MEMORANDUM FOR RECORD

SUBJECT: Request for a Permit Modification to the Sea Island Reserve Project, SAS-2015-00742

SEA ISLAND CLOISTER RESERVE

PROPOSED ACTIVITY:
BEACH RENOURISHMENT & GROIN
CLIENT:
SEA ISLAND ACQUISITION, LLC
LOCATION: GLYNN COUNTY, GA.
DATE: 9/10/15 REV: 4/2/2020 DRAWN BY: JWR SHEET: 2
JOB NUMBER: J-25447 REVIEWED BY: CLG SCALE: 1" = 100'

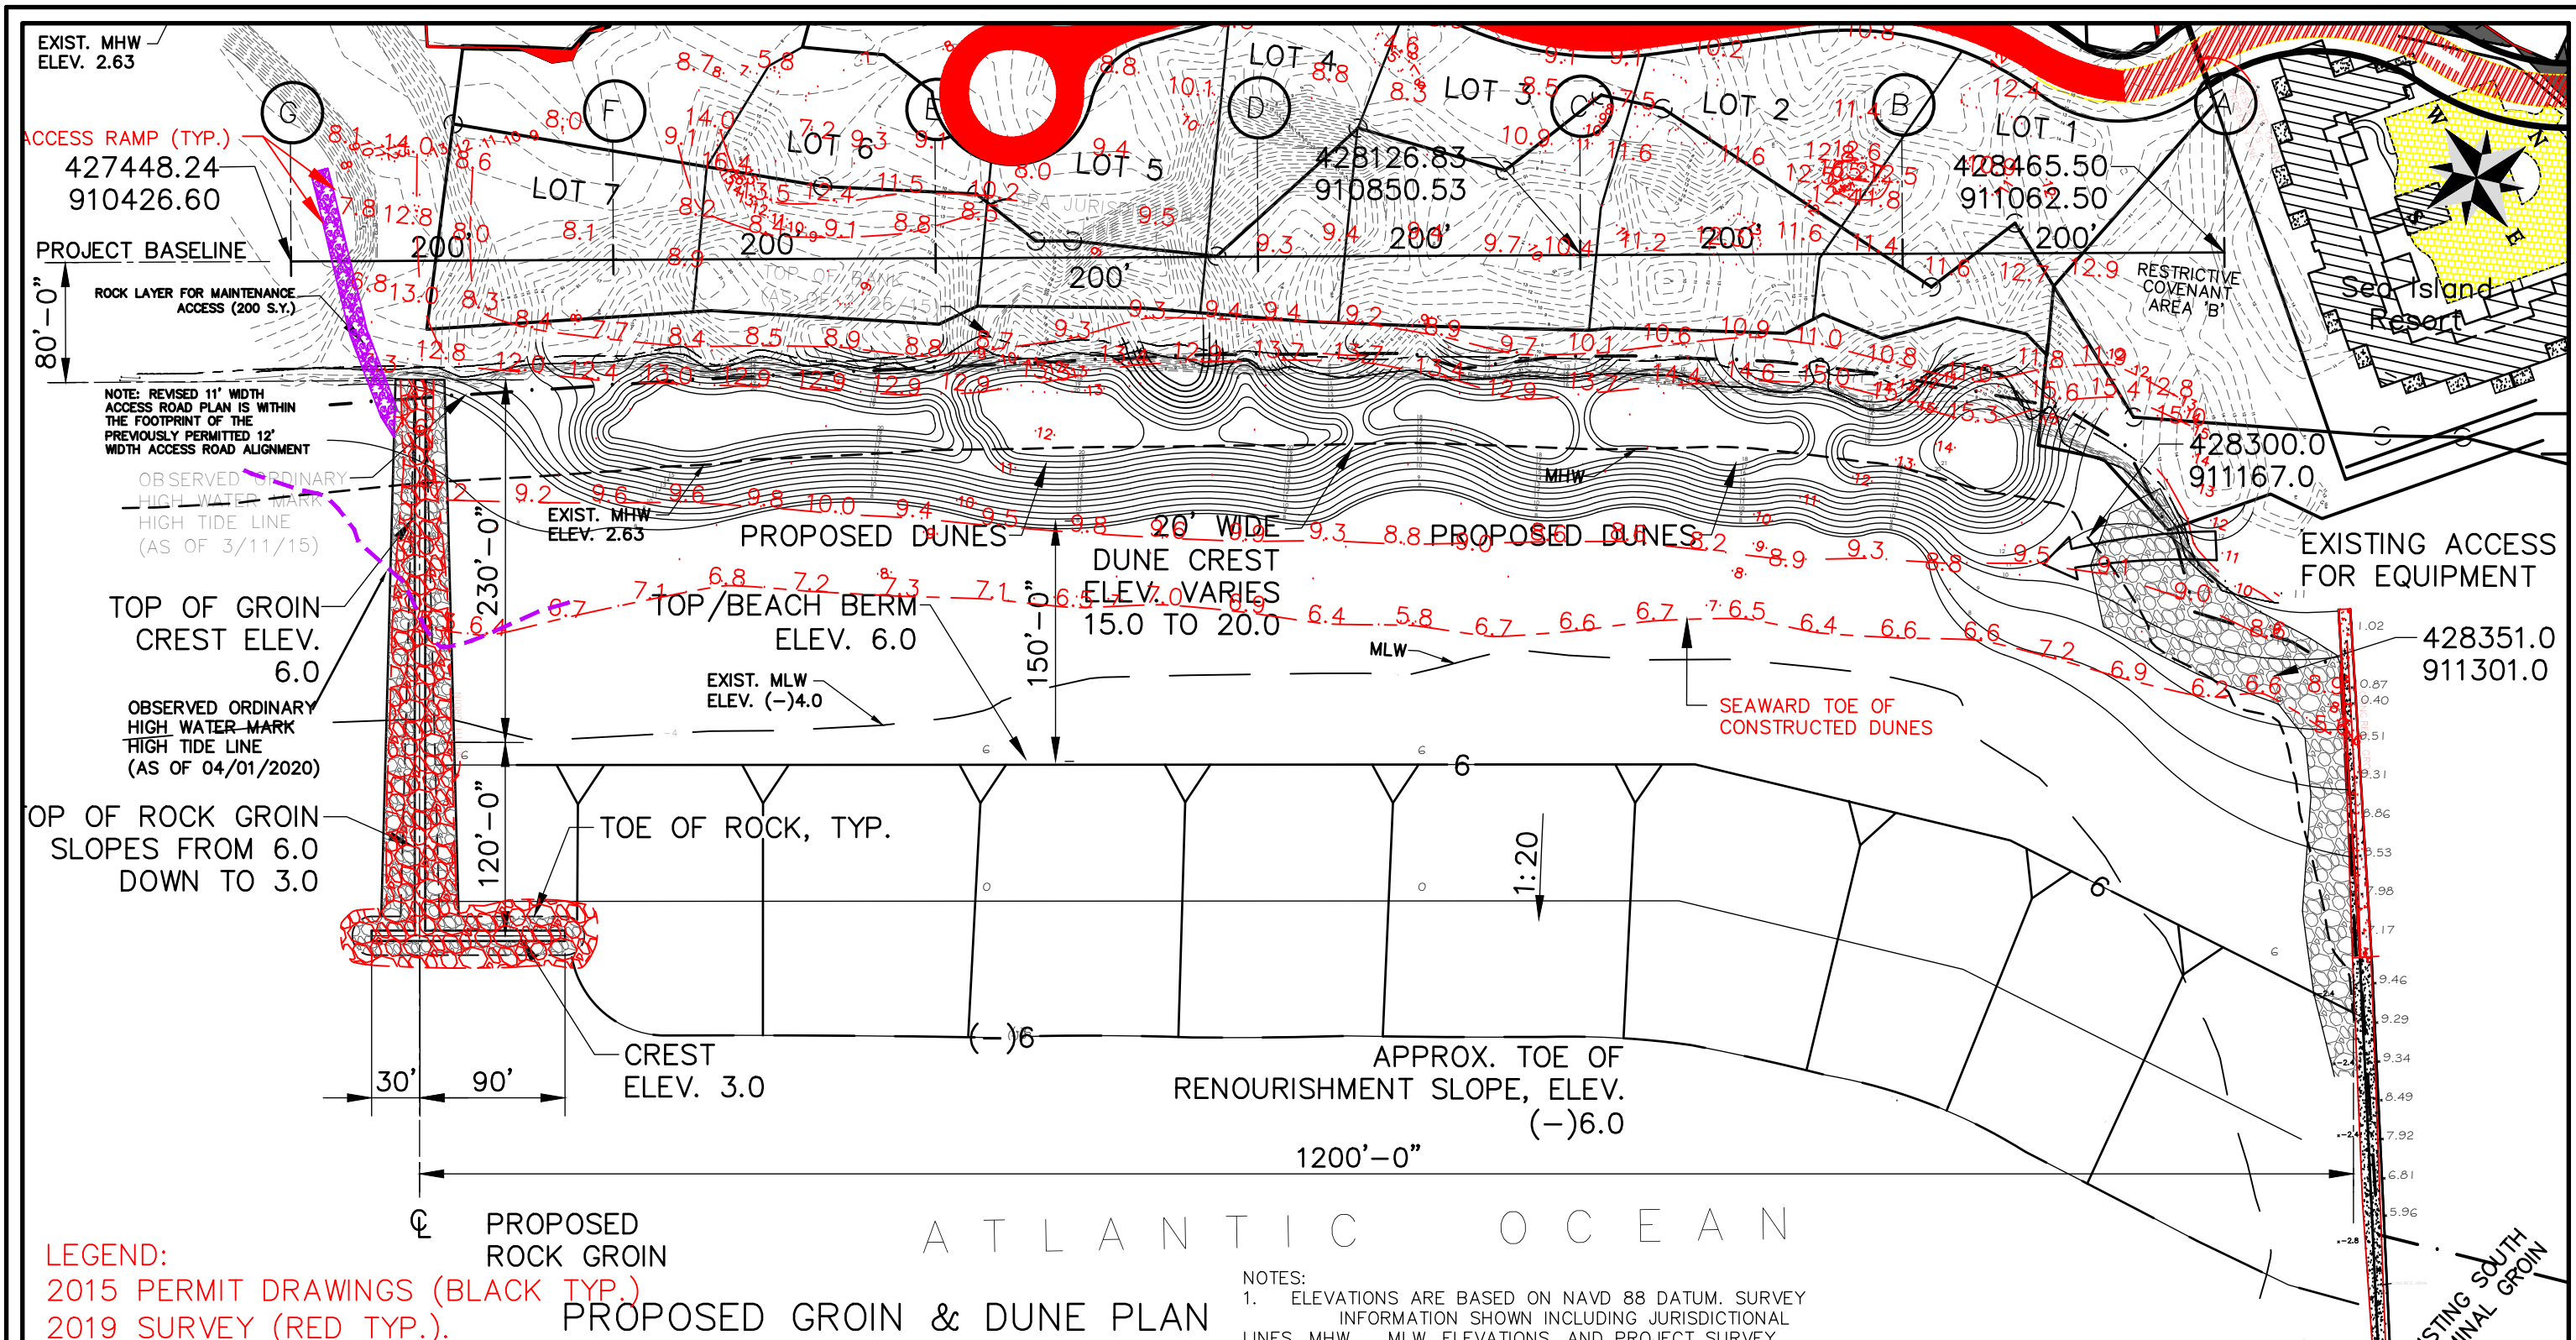
5. As authorized by Georgia CRD, the access road would be constructed within the same footprint as what is authorized in the Corps’ permit modification. However, the width of the road has been reduced from 15’ to 11’. As a result, the permittee has requested a modification to the Corps permit to reflect the change in the width of the road. Based on the March 11, 2015 delineation, a small portion of the road would be located within the Corps’ jurisdiction.

10. Based on the above information, the Corps is granting the permit modification. All General and Special Conditions issued with the 2018 permit will continue to be effective with the above referenced modification.
